V2500-A1 SERIES PROPULSION SYSTEM SERVICE BULLETIN

This document transmits the Initial Issue of Service Bulletin NV2500-71-0292 and the Initial Issue of the Supplement

NACELLE – POWERPLANT – COWL, AIR INTAKE – REPLACEMENT OF THE P2T2 MOUNTING BRACKET
ASSEMBLY AND SEALING BLOCK

V2500–NAC–71–0292

Replacement of the P2T2 Mounting Bracket Assembly and Sealing Block
Figure 1

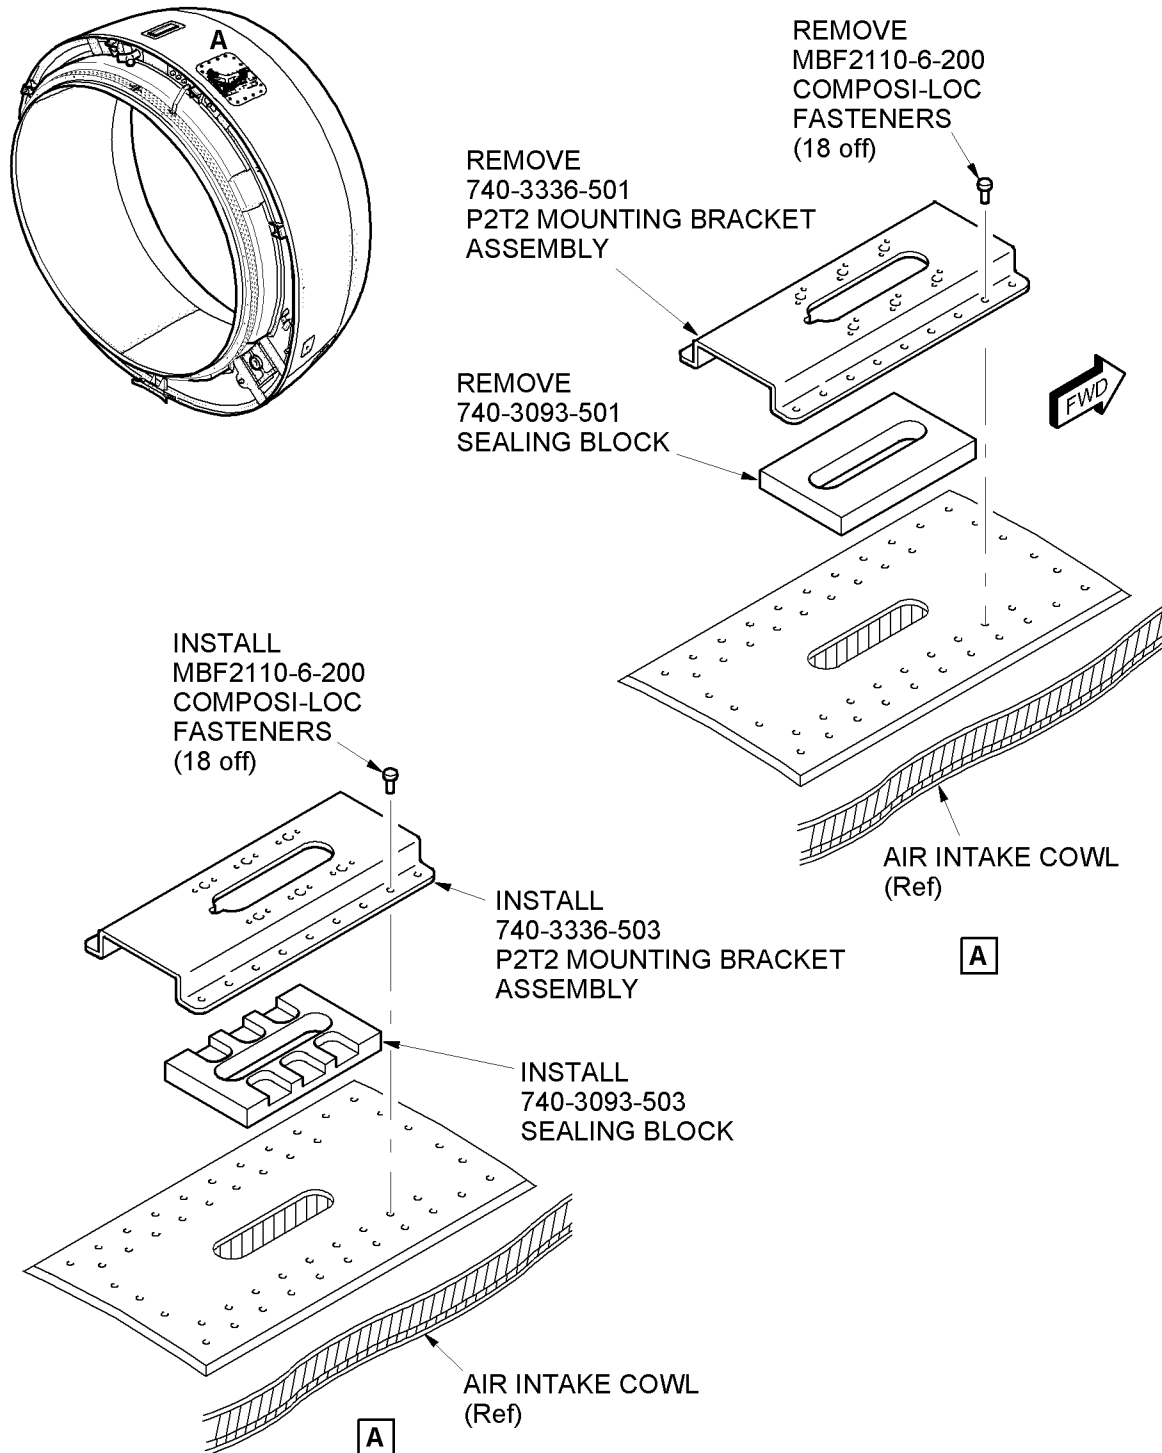
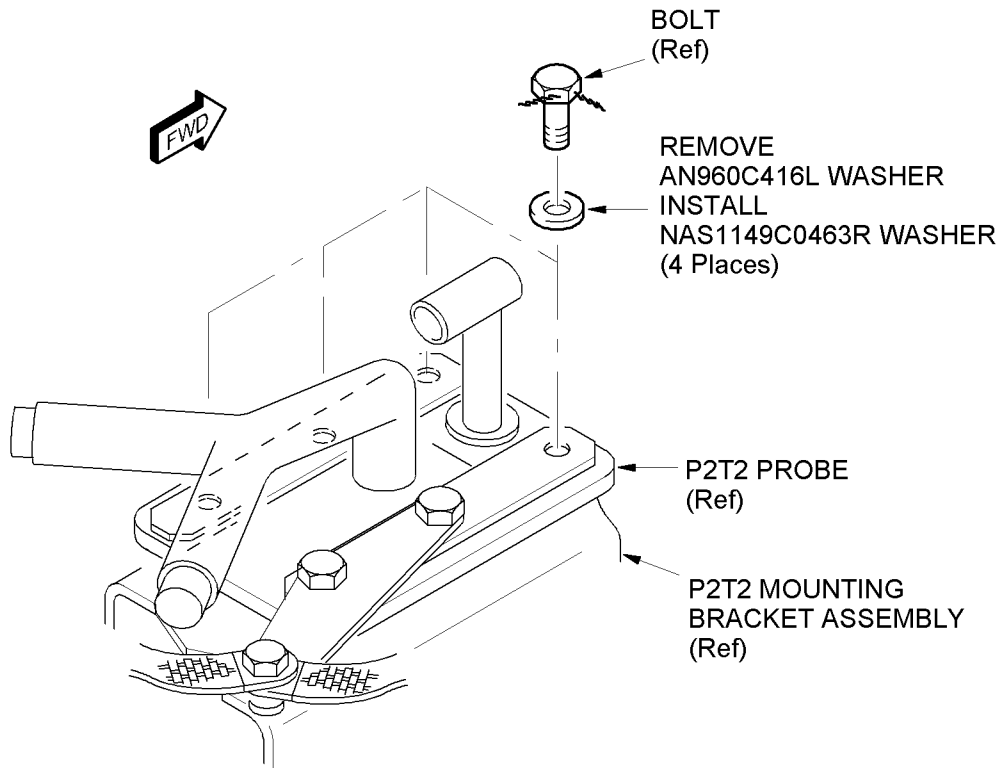
- (a) Carefully remove the 18 MBF2110-6-200 Composi-loc fasteners to release the 740-3336-501 P2T2 Mounting Bracket Assembly and the 740-3093-501 Sealing Block from the Air Intake Cowl. Refer to Figure 1.
- (b) Remove the 740-3336-501 P2T2 Mounting Bracket Assembly and the 740-3093-501 Sealing Block from the Air Intake Cowl.

- (c) Remove the inboard flange from the old 740-3336-501 P2T2 Mounting Bracket Assembly and firmly secure to the inboard flange of the new 740-3336-503 P2T2 Mounting Bracket Assembly. Make sure that the flange edges are flush.

- (d) Remove the outboard flange from the old 740-3336-501 P2T2 Mounting Bracket Assembly and firmly secure to the outboard flange of the new 740-3336-503 P2T2 Mounting Bracket Assembly. Make sure that the flange edges are flush.

- (e) Drill 18 3/32 in. (2,40 mm) pilot sized holes from the old flanges into the 740-3336-503 P2T2 Mounting Bracket Assembly.
- (f) Progressively increase the size of the 18 holes to 0.193 0.197 in. (4,90 5,00 mm).

- (l) Use CoMat 04-005 Jointing Compound as a faying surface between the Mounting Bracket Assembly, the Sealing Block and the Air Intake Cowl and install the 740-3093-503 Sealing Block and the 740-3336-503 P2T2 Mounting Bracket Assembly to the Air Intake Cowl with the 18 MBF2110-6-200 Composi-loc fasteners. Refer to IAE/V2500 Standard Practices/Processes Manual, Chapter 70-36-02.

New configuration of P2T2 Probe installation – For the complete removal/installation of the P2T2 Probe refer to the AMM
Figure 2

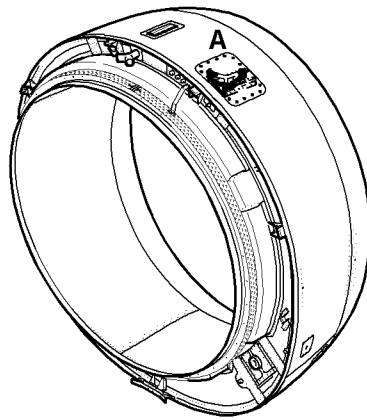
NOTE: There is no requirement for the Nutplate to be installed as part of the new P2T2 Mounting Bracket configuration. Consequently, to allow for usage of the existing bolts, new, thicker washers have been introduced as part of the P2T2 Probe installation. Refer to Figure 2.

- (3) Install the P2T2 Probe as instructed in the A320/V2500-A1 A319/A320/A321/V2500-A5 Aircraft Maintenance Manual, Task 73-22-11-400-010. Use the four NAS1149C0463R in lieu of the four AN960C10L Washers.
